**HINCKLEY NATIONAL
RAIL FREIGHT INTERCHANGE**

**Geometric Design Strategy Record (GDSR) – M69 Slip
Roads and Comment Log**

Hinckley National Rail Freight Interchange (NRFI) Development Consent Order (DCO) - M69 J2 Scheme Geometric Design Strategy Record (GDSR) Review

Ref: HRF-BWB-HML-M69-RP-CH-00101

HRF-BWB-HML-M69-DR-CH-0150 Status Rev

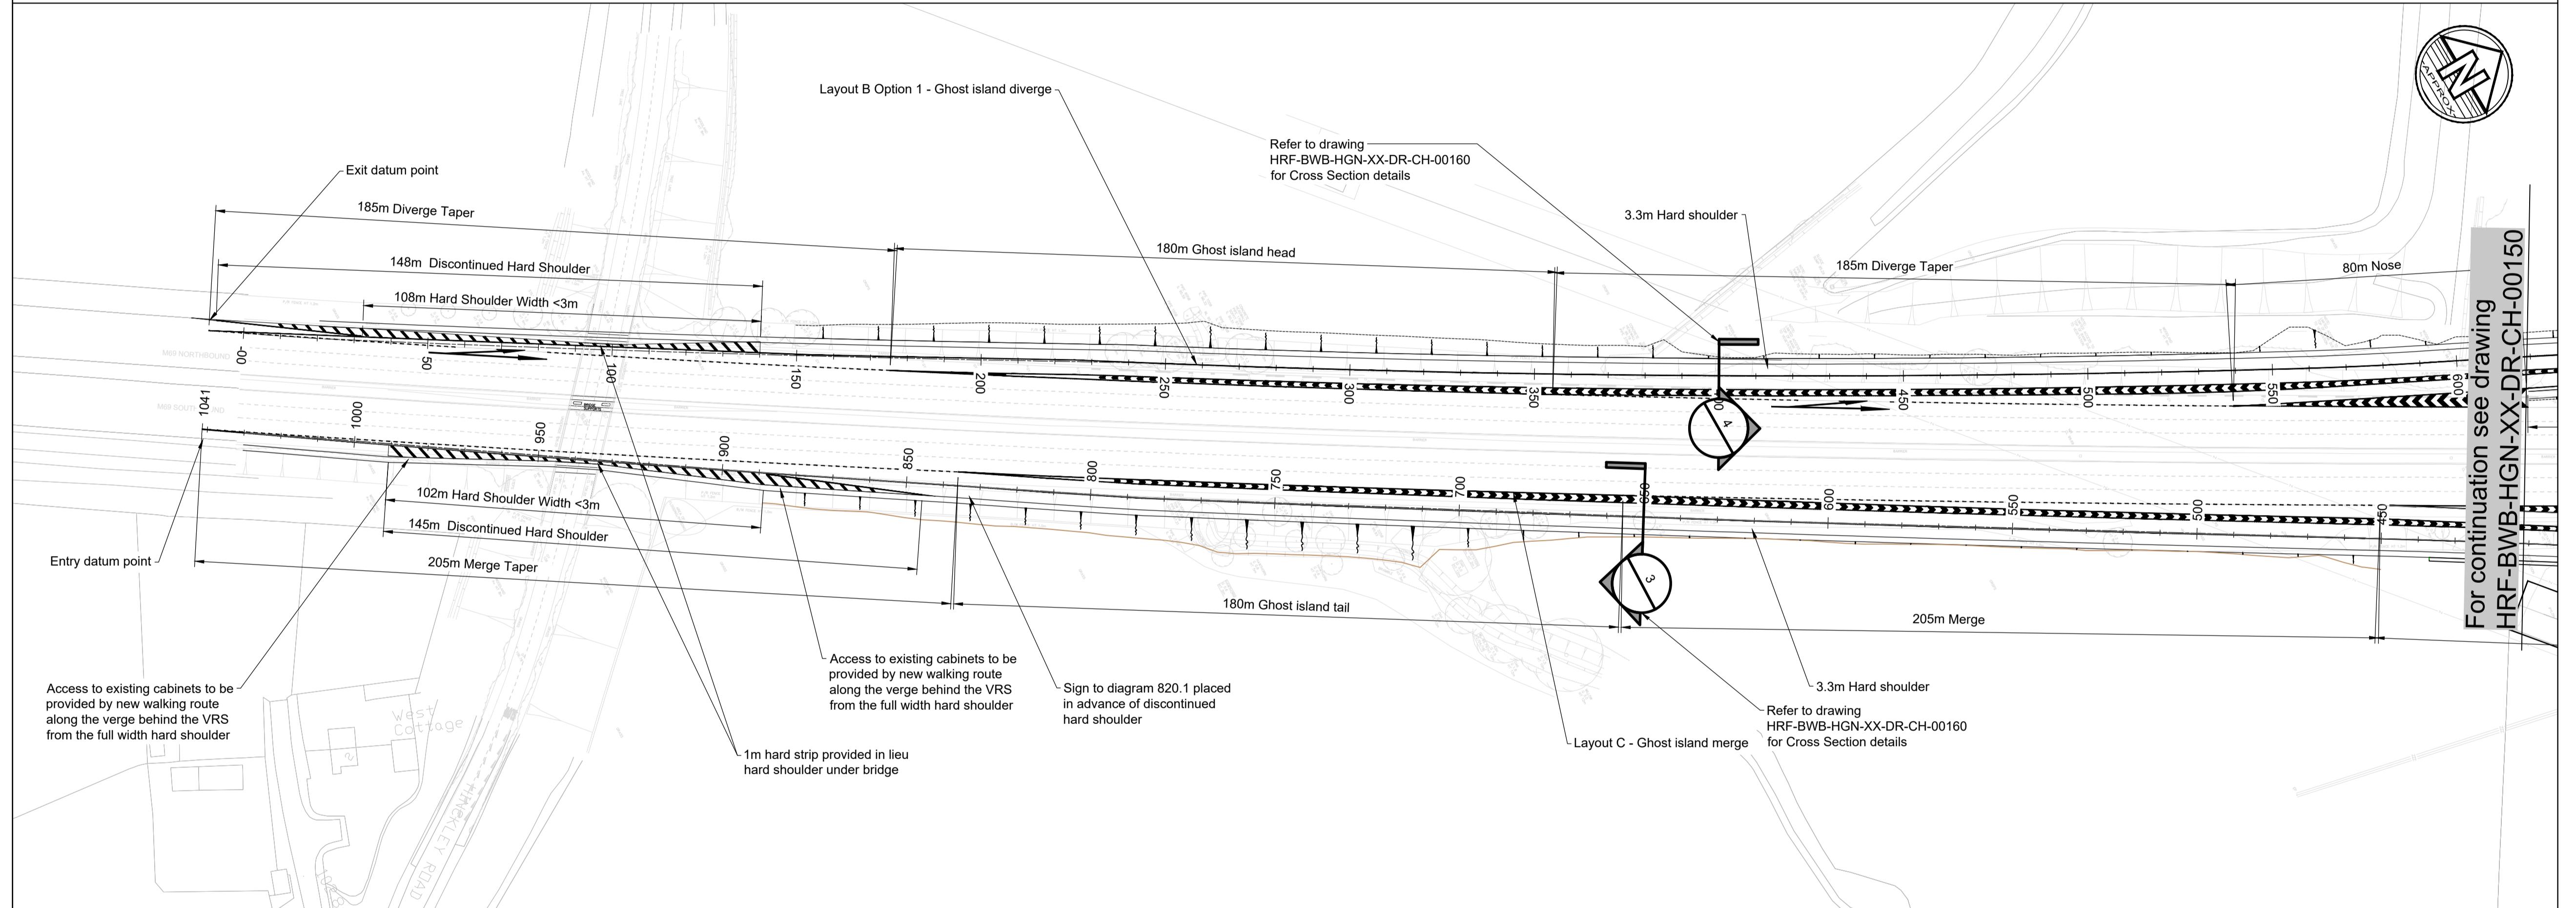
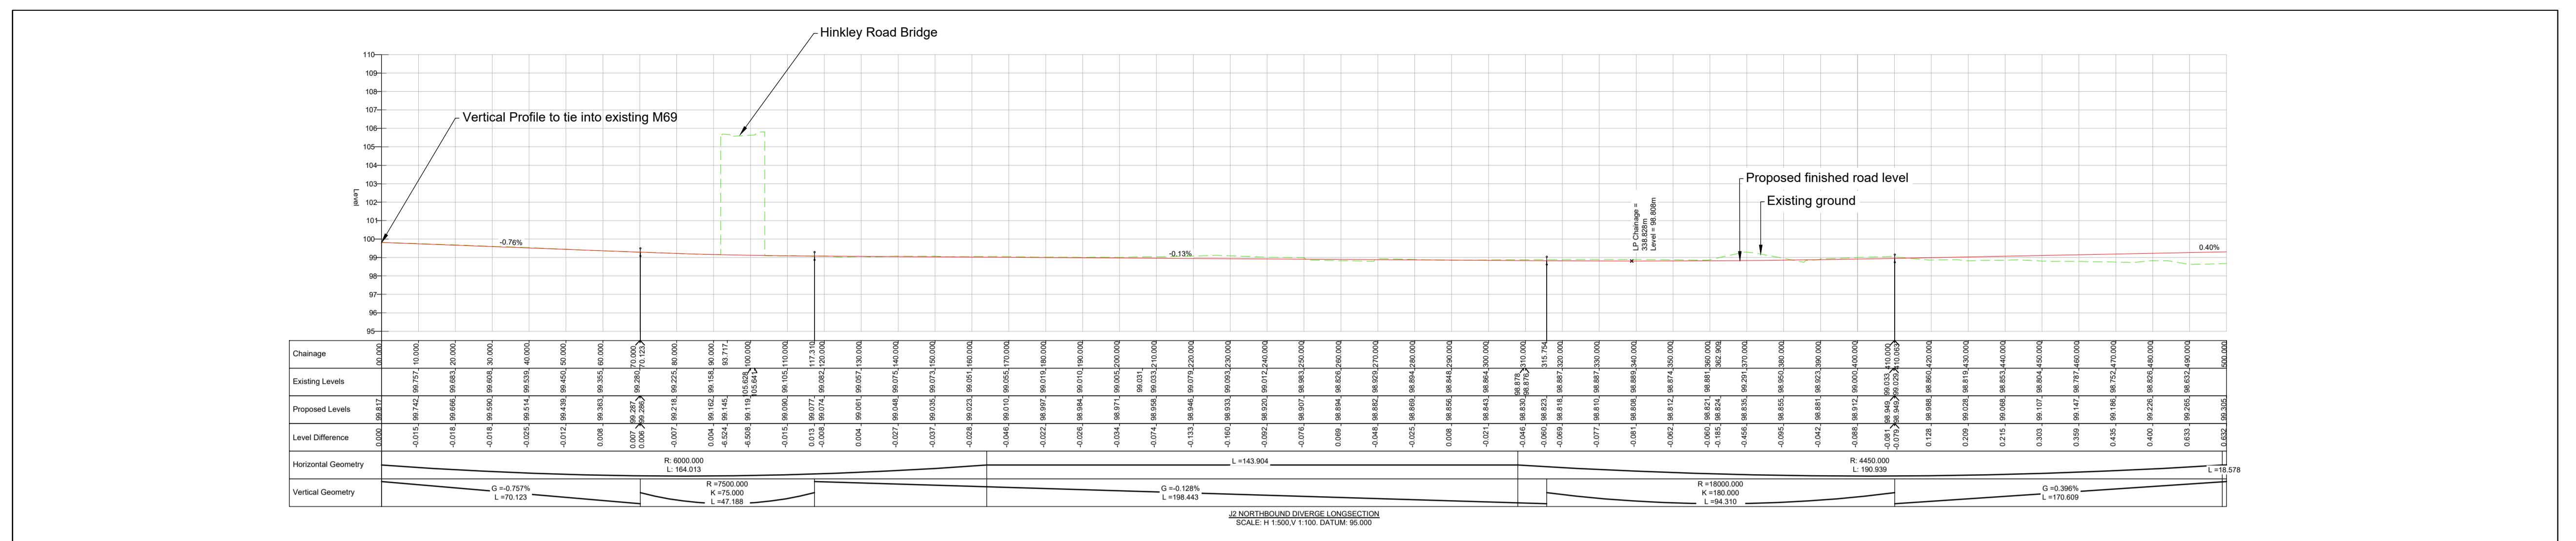
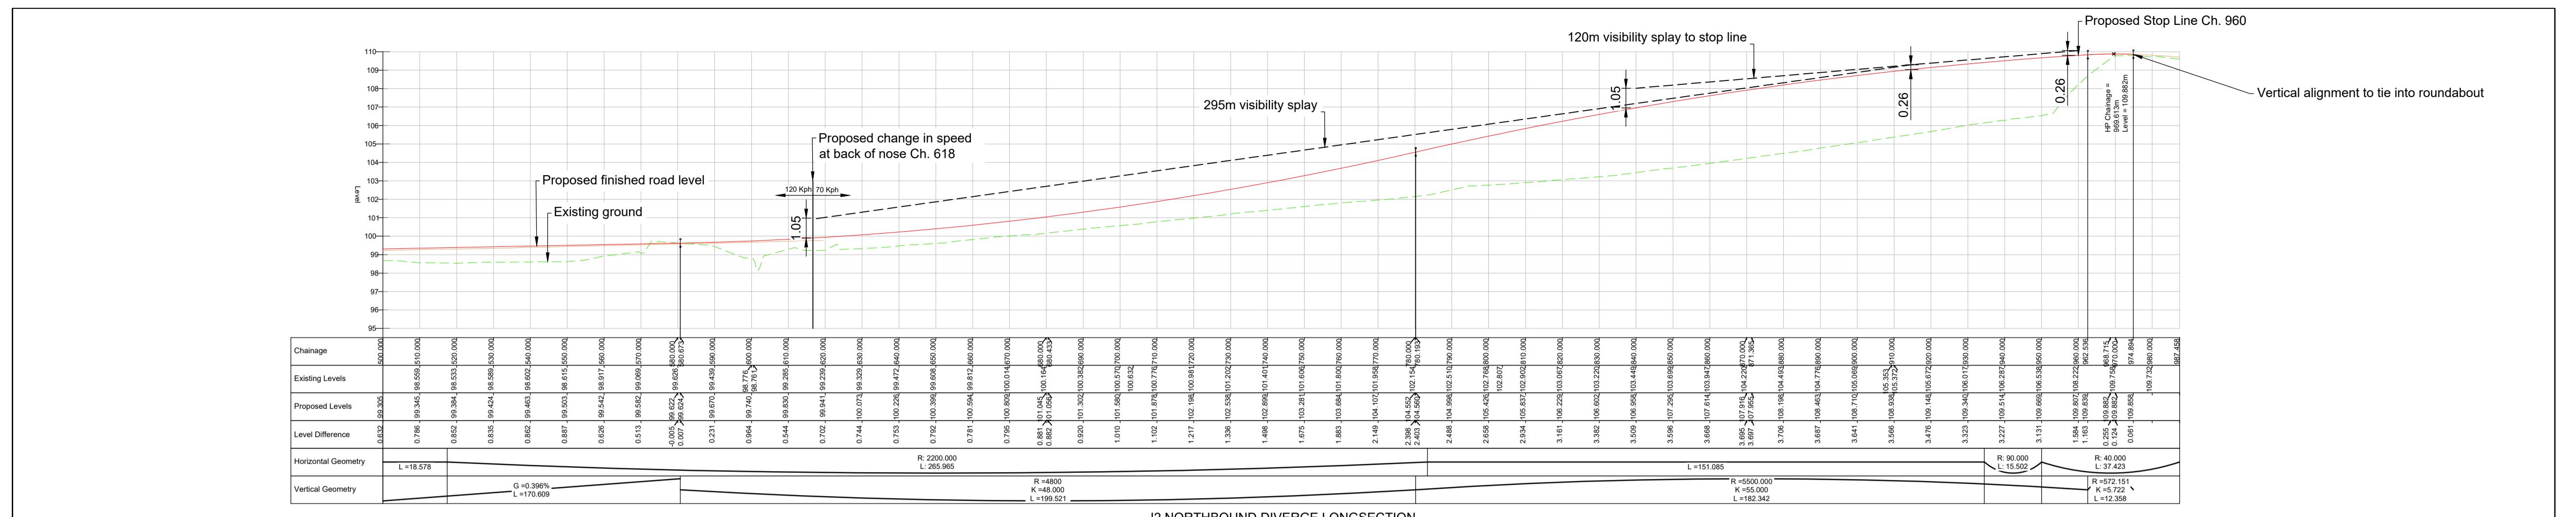
Comment Author	NH Comment	BWB Response	NH Comment	BWB Response
Issue	Design Element				
1	Horizontal Design	Minimum nose ratio is not shown on drawing 150	This is beyond the cut line and so is shown on drawing 151	Noted and accepted*.	
2	Horizontal Design	The table showing horizontal geometry of the proposed diverge slip road makes no reference to the appropriate DMRB Standard or requirements.	Paragraphs have been added before the relevant tables to reference the design documents that the parameters are derived from.	Noted and accepted*.	
3	Horizontal Design	Chainage 517.434m to 783.400m - absence of a corresponding cross-section to show use of 2.5% superelevation	Note has been added in the table to say 2.5% superelevation is used. Cross section has been added to the sections drawing through this area.	Noted and accepted*.	
4	Horizontal Design	It should be noted that an adjustment factor of 1.05 should be applied to the merging flow due to the merging percentage of HGVs and gradient.	Adjustment factors of between 1.05 and 1.10 (depending on the exact percentage of HGVs) have been added to the calculations. These do not affect the outcome of the calculation as noted.	Noted and accepted*.

5	Horizontal Design	The minimum nose ratio (1:40 required) is not referenced on drawing 150.	This is beyond the cut line and so is shown on drawing 151. The achieved merge ratio is 1:24 which is a larger angle than with a 1:40 ratio and so the 'minimum' requirement here is met (we discussed this in the	Noted and accepted*.	
6	Weaving	Requirement for a weaving assessment not covered in the GDSR	A weaving assessment section has been added and calculations appended to the report.	Noted and accepted*.	
7	Sight Distance	No reference in the GDSR to the requirements for stopping sight distance.	A paragraph has been added to the SSD section of the report noting the relevant paragraphs of CD 122.	Noted and accepted*.	
8	Vertical Design	The Standards associated with the design requirements for vertical design of the proposed slip roads should be noted for completeness in the GDSR.	Paragraph added in vertical design section.	Noted and accepted*.
